AMEREN/UE  
DOCUMENT CONTROL SYSTEM  
DOCUMENT TRANSMITTAL

TCN NO. 00-0442

1. PROCEDURE NUMBER EIP-ZZ-03010 REVISION NO. 007  
PROCEDURE TITLE HAZARDOUS CHEMICAL/OIL SPILL RESPONSE/SPILL  
CLEANUP IMPLEMENTING PROCEDURE

TEMPORARY CHANGE NOTICE REQUEST FORM

**SHIFT SUPERVISOR CHECKLIST FOR HAZMAT/OIL RESPONSE / CLEANUP**

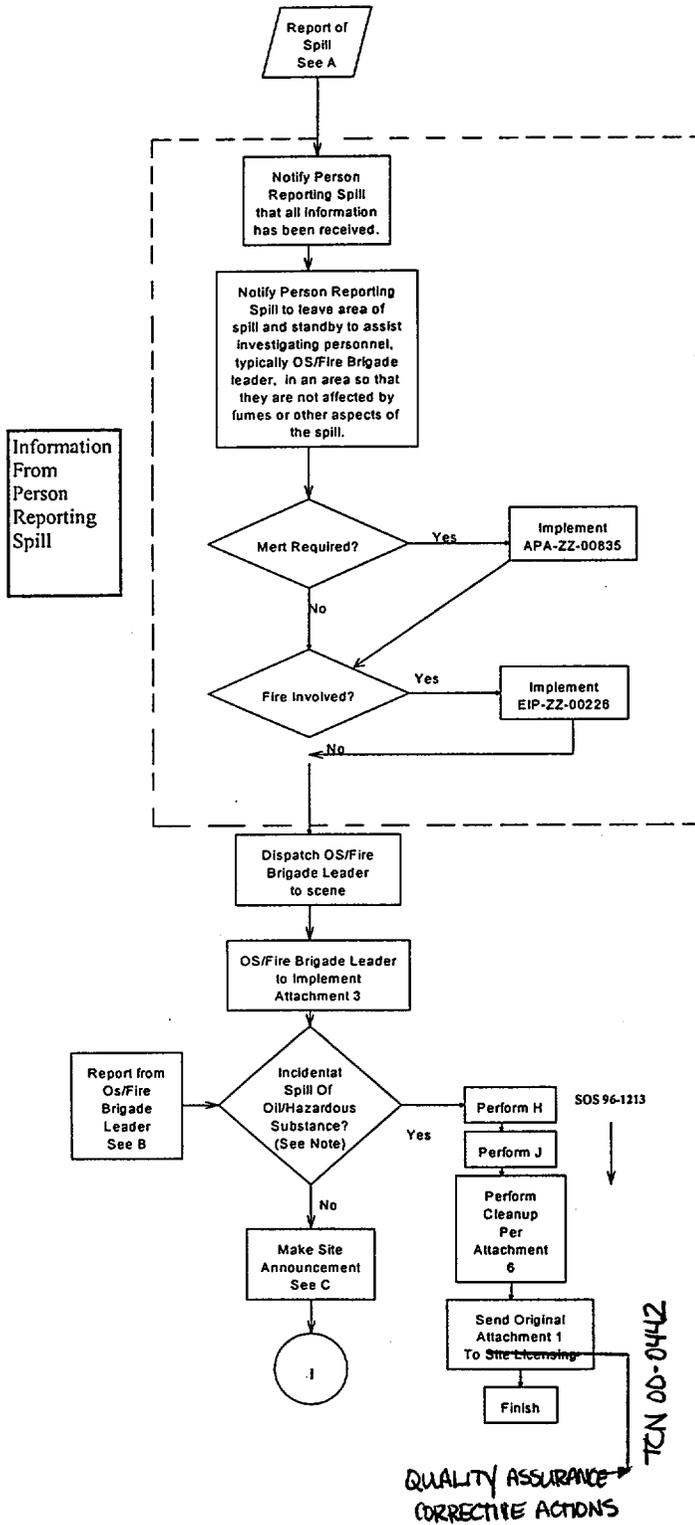
2.1 PAGE NUMBERS AFFECTED BY CHANGE Pages 1 and 4 of Attachment 1

Change to flow chart instructions that route Shift Supervisor Checklist as follows  
Send Original Attachment 1 to SITE LICENSING to instead direct routing to QUANTITY 17 2000  
ASSURANCE CORRECTIVE ACTIONS
